REMARKS

Drawings

Fig. 5A — Add "A"

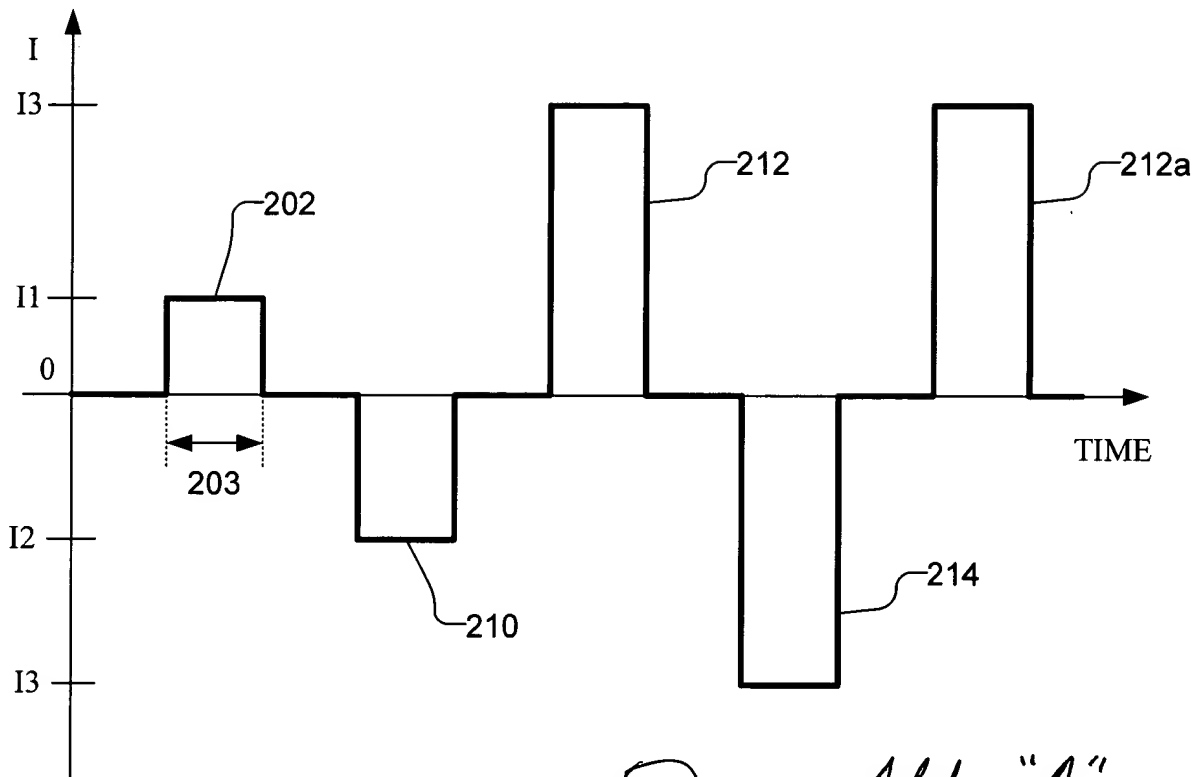
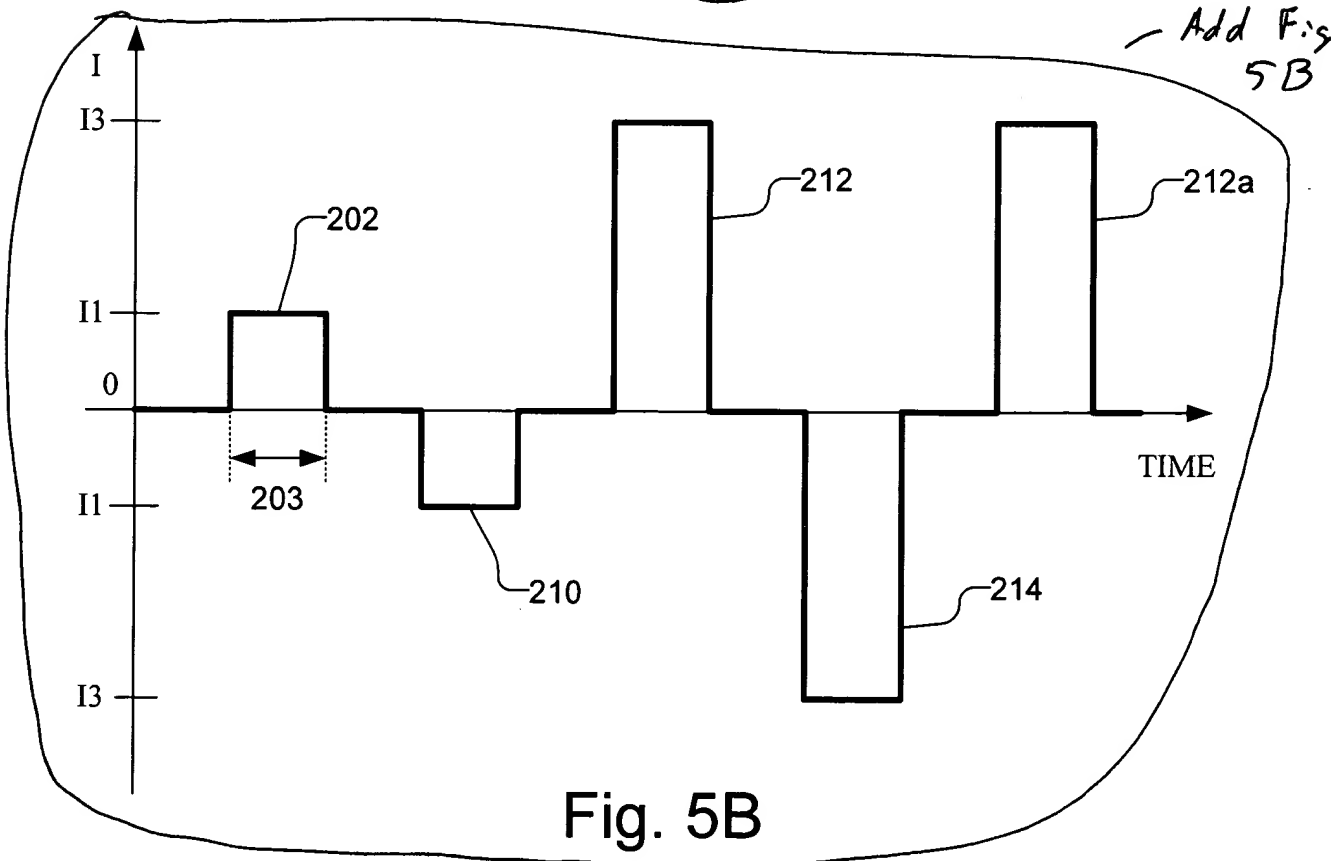
The Examiner did not accept the substitute drawings that were previously submitted. The Examiner stated that it is improper to provide two timing diagrams in a single figure. As per the Examiner's suggestion, Fig. 5 is amended to include Figs. 5A and 5B, along with corresponding changes in the specification.
